Millcreek

Planning Commission Meeting | October 16, 2025

Villa Vista Townhomes

Development Agreement (CCOZ)

SITE PLAN

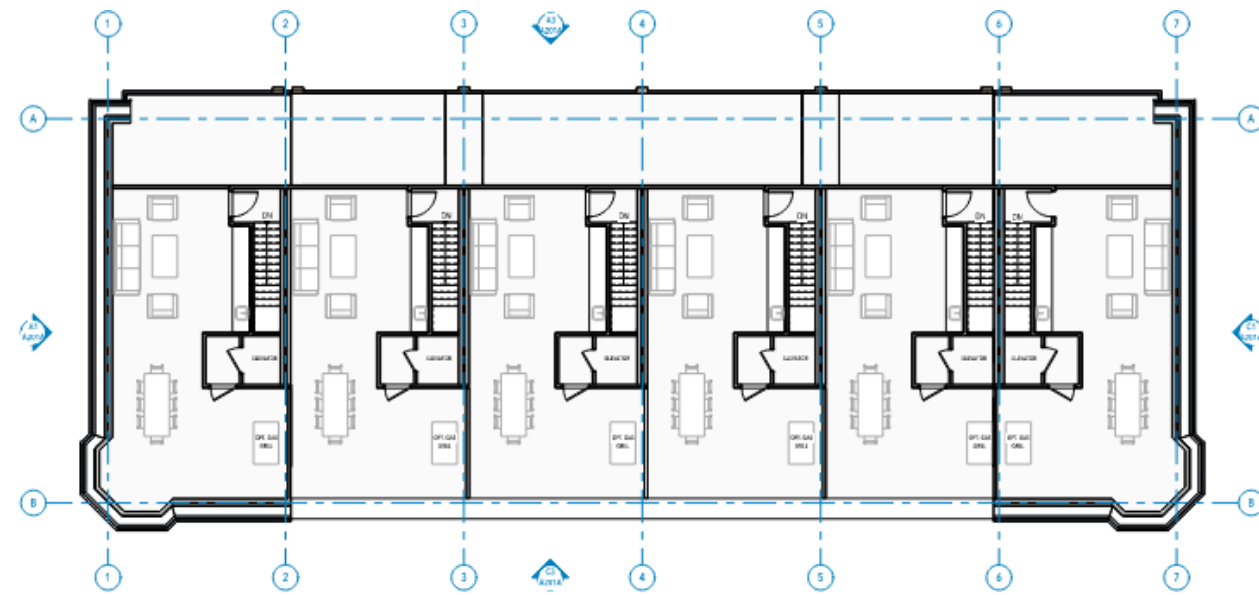
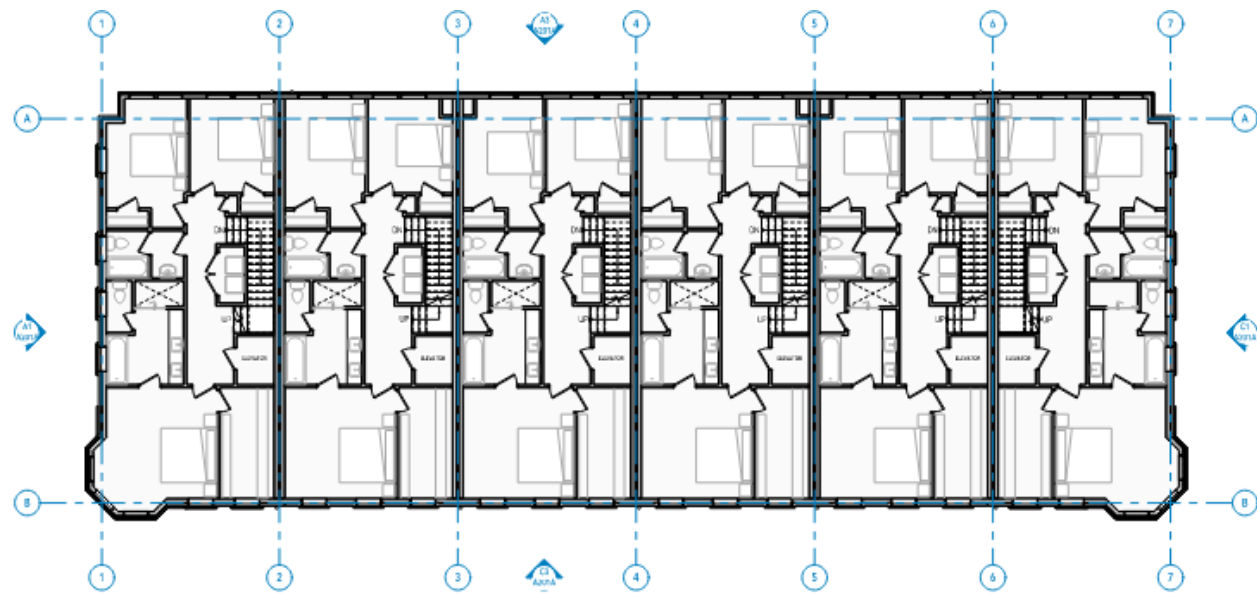
- Landscaping to be subject to MKZ 18.64 (Landscape standards). Proposal currently meets the requirement of allocating, at least, 30% of the overall lot size as open space.

- Parking to be subjected to MKZ 18.63 (Parking and Mobility Standards).
 - The Project shall have at least thirty-six (36) parking stalls, which shall be contained within the eighteen individual two-car garages.

- Additionally, as per the prescribed cross section for **neighborhood streets**, depicted in Figure 18.47.7 and in Table 18.47-8 within MKZ [18.47.060](#) (CCOZ Design Standards), the project will include seven (7) on street parking stalls and one (1) ADA parking stall, which will be dedicated to the City as part of the Right-of-way.

- Millcreek will require five (5) guest parking spaces [18 (units) x 0.25 (spaces per unit for visitor parking) = 4.5 stalls, rounded to five. These stalls will be located within the forementioned on street stalls, which may be used as shared parking serving Villa Vista Ave.

- The Subject Property has one access from Villa Vista Ave to the complex, measuring to be 25' in width, meeting the 2019 Transportation Master plan. Access has been reviewed and accepted by Unified Fire.

BUILDING 1 & 2 - FLOOR PLAN - LEVEL 3
AS11A 1/8" = 1'-0"

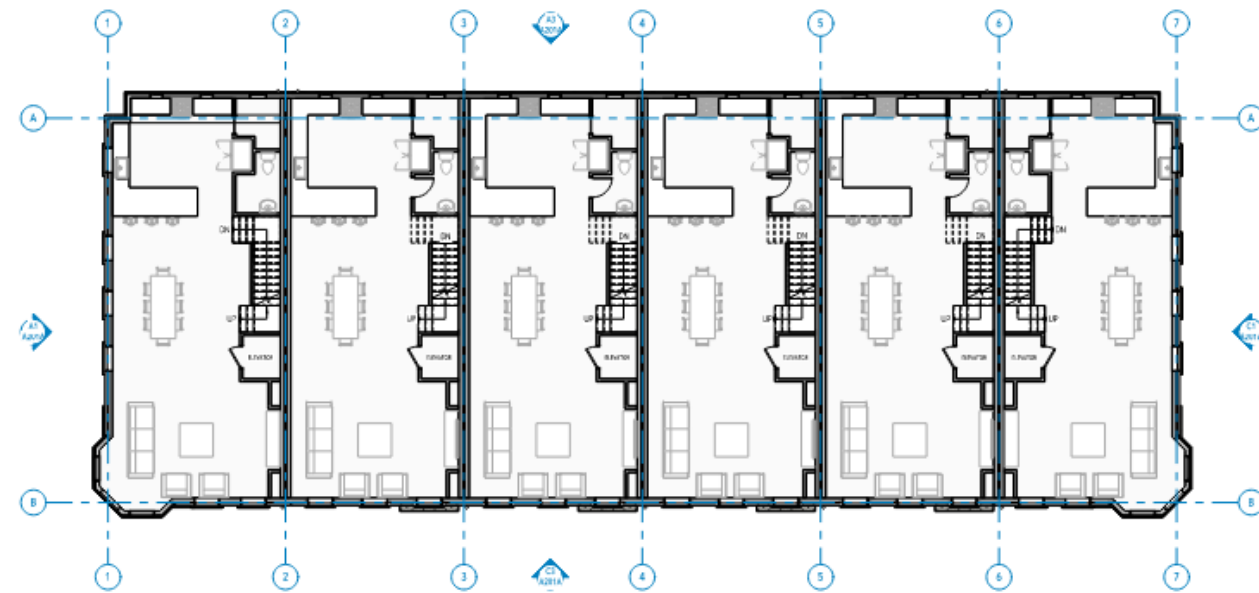
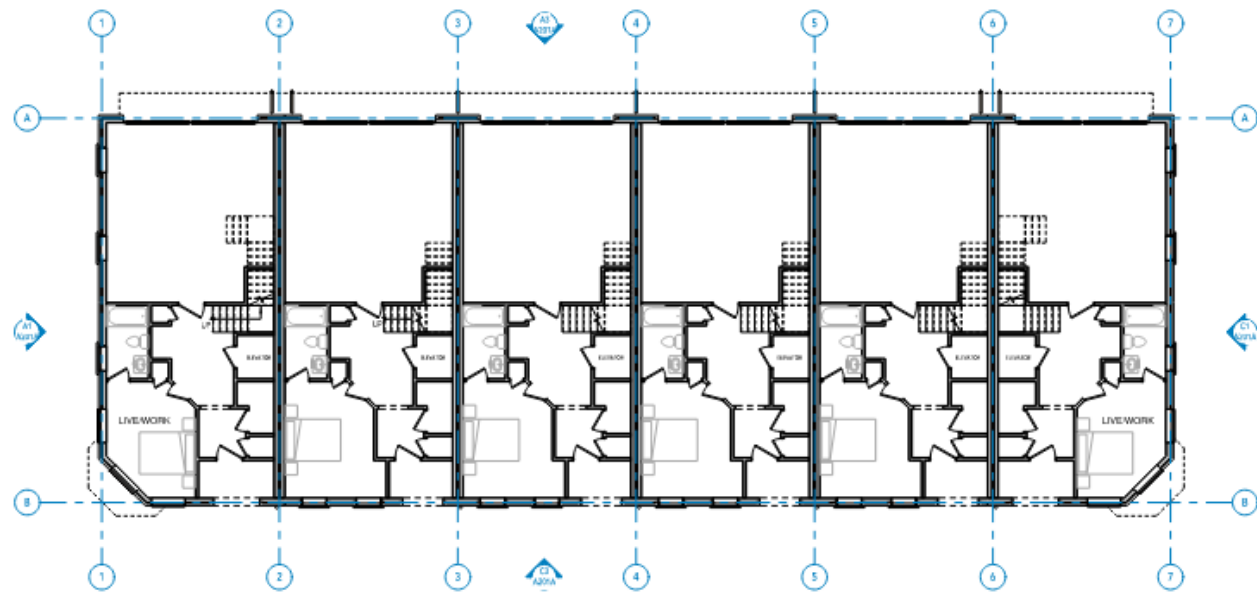
Building Stepbacks along Side and Rear Property Lines: For any building over 40 feet in height, the following building stepbacks apply:

When a residential use occupies the first story, windows shall constitute at least **33 %** of first story street-facing facades. Windows shall constitute at least **25%** of all upper-story facades. Currently, the applicant has provided **18% and 20%**

- Rear Property Line. A five-foot (5') stepback along a façade facing the rear property line is required between the top of the first story and the top of the third story and upper stories. Building setbacks greater than 15 feet in depth from a rear property line are not required to provide a five-foot (5') building stepback.
- Side Property Line. 10-foot stepback along a façade facing a side property line is required between the top of the first story and the top of the third story and upper stories. Building setbacks greater than 15 feet in depth from a side property line are not required to provide a 10-foot building stepback.

Building Stepbacks along Streets and Property Frontages: For any building or development that is over 40 feet in height or located on properties fronting on the Millcreek Common, 3300 South, Richmond and/or with frontage on Highland Drive, a 20-foot stepback of the building façade, facing any street, is required between the top of the first story and the top of the third story and upper stories. This building stepback shall incorporate one of the two stepback variations:

- A segmented stepback, such as, a 10-foot initial stepback between the first and second stories followed by an additional 10-foot stepback between the second and third stories as depicted in Figure 18.47.13, or;
- A full stepback of 20 feet between the first and third stories, that is utilized as a usable space for building tenants or businesses occupying the building, as depicted in Figure 18.47.14.

When a residential use occupies the first story, windows shall constitute at least **33 %** of first story street-facing facades. Windows shall constitute at least **25%** of all upper-story facades. Currently, the applicant has provided **20%**.

Irrigation Ditch

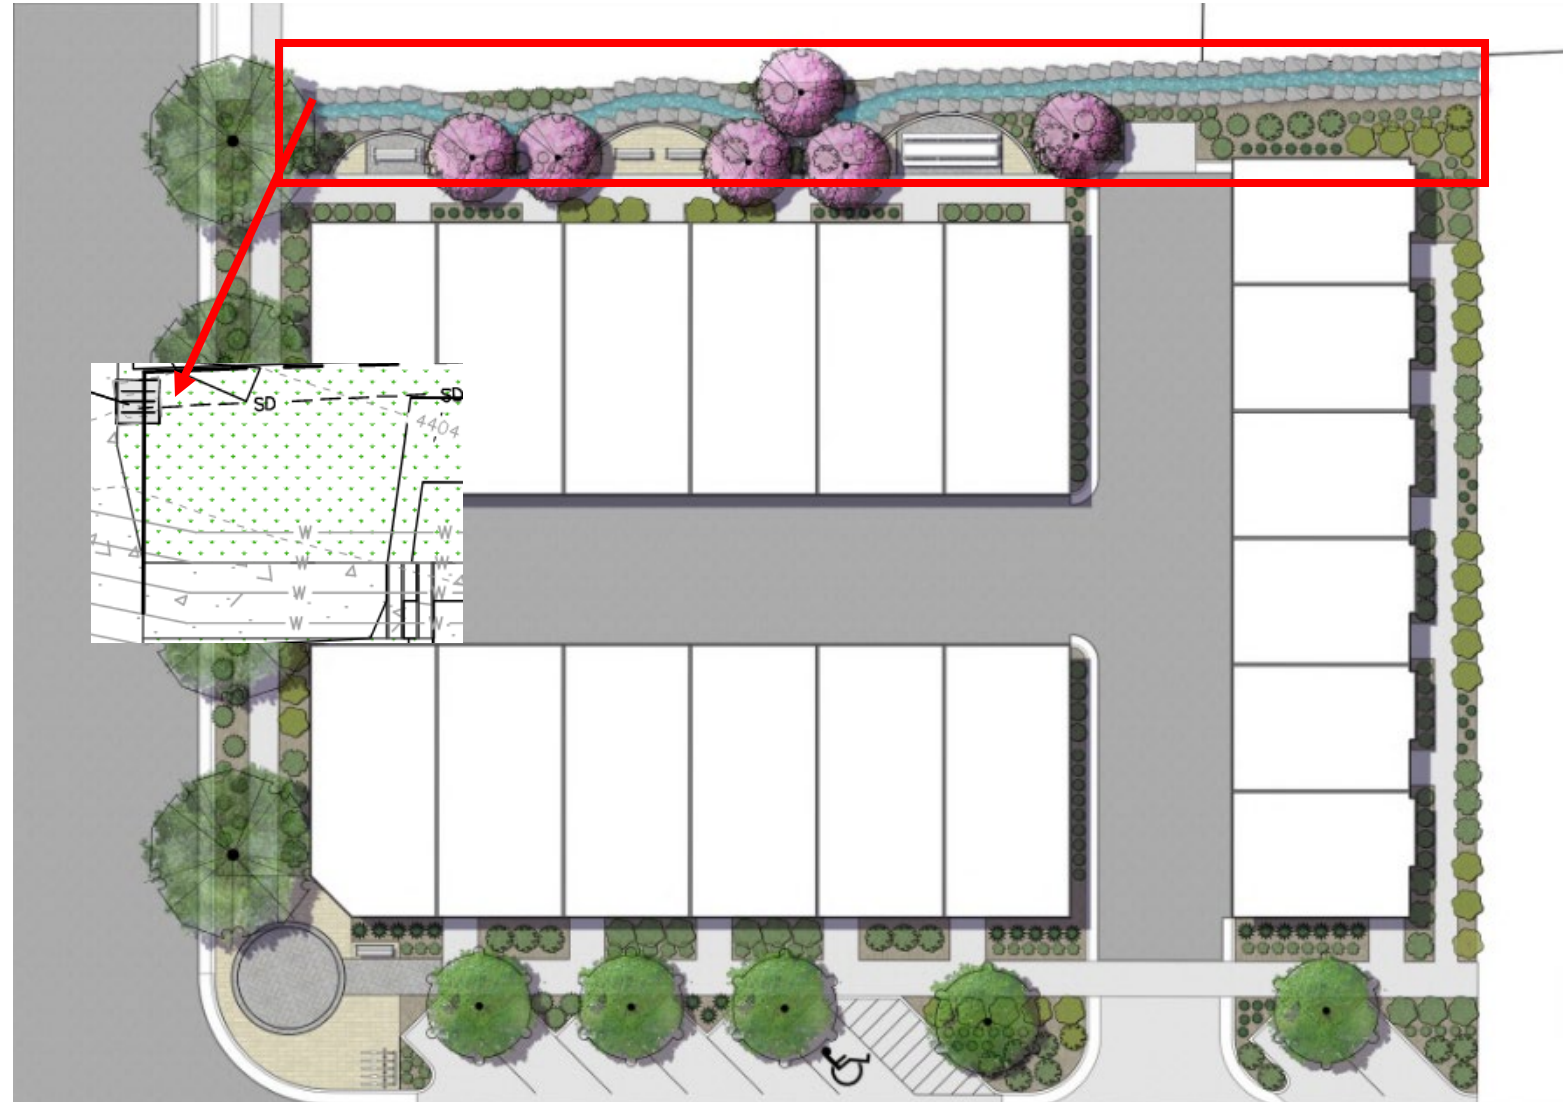
Ditch running across northern property line.

Historically, a potential reason for flooding neighborhood near Richmond St.

Neighbors have asked for new clean out boxes and/or any other remedy to mitigate flooding on Richmond St.

Any mitigation will need to be identified on Development Agreement.

- **Ditch Maintenance:** As request by Lower Millcreek irrigation company, the applicant will be required to install two closed clean-out boxes at each end of the ditch that runs across the entire width of the property, in an effort to mitigate historic flooding in the neighborhood.
